Appendix M

Homebuilder letters and maps regarding storm water concerns in platted subdivision

RE: Autumn Park Plat 2 drainage swales
PROJECT # 8630-06K.702

RE: Autumn Park Plat 3 drainage swales
PROJECT # 8630-06K.703

SHEET NUMBER: C2.1

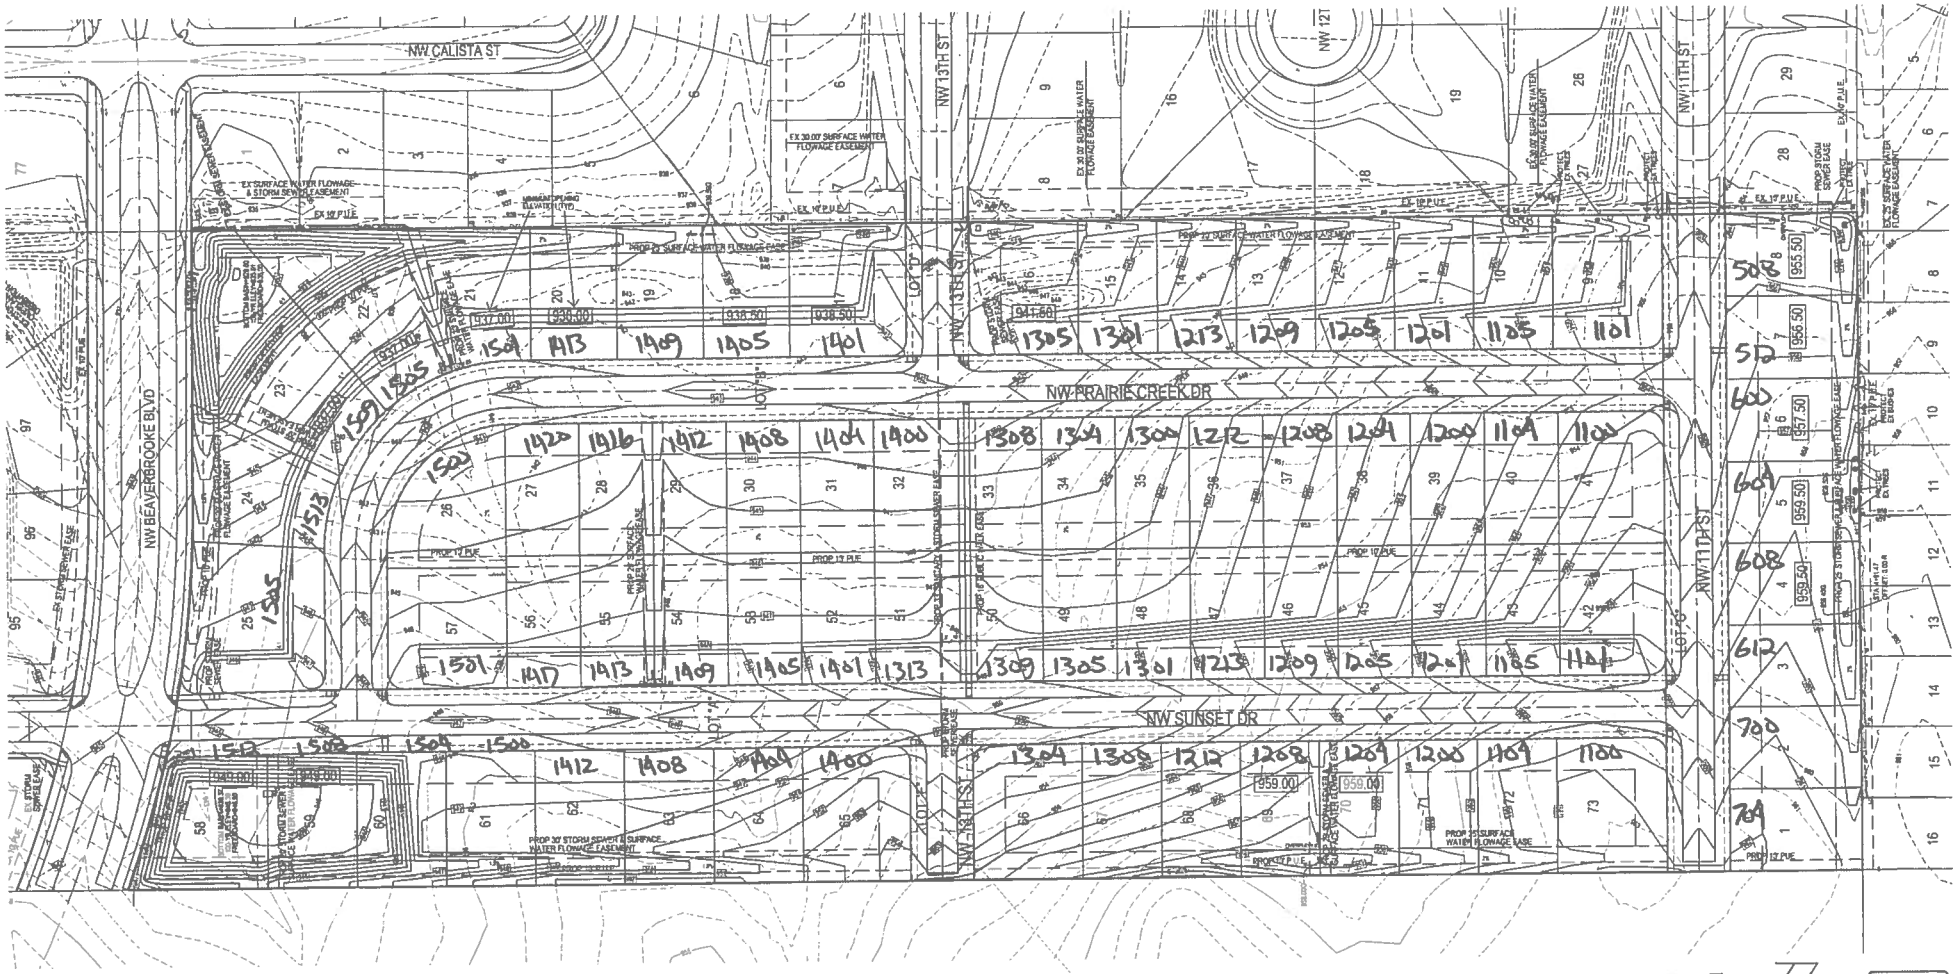
1. Stormwater emergency overflow spillway(s), please grade to the appropriate details on plan sheets C2.1 & C6.1:
   a. Pond in lot 58 (**1512 NW Sunset Ln.**) – ***40-foot*** *bottom width, elevation* ***945.39*** – *NE corner of lot overflows sidewalk onto NW Beaverbrooke Blvd.*

2. Stormwater flowage easement swale(s), please grade in accordance with details on plan sheets C2.1 & C6.1.

TYPICAL RIGHT OF WAY GRADING AT STORM WATER OVERFLOW POINTS

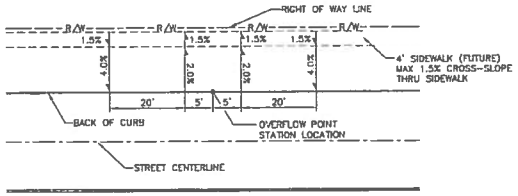
1. Stormwater emergency overflow spillway, please grade to the appropriate detail(s) on plan sheet 2:
   a. between lots 17 & 18 (**2313 & 2401** NW **Springbrooke Dr.**, respectively)

b. trail overflow in ROW for lot 1 (**2612** NW **Springbrooke Dr.**)
   c. trail overflow in ROW for lot 29 (**2613** NW **Springbrooke Dr.**)
2. Stormwater flowage easement swale(s), please grade in accordance with details on plan sheets 2, 6 & 7.
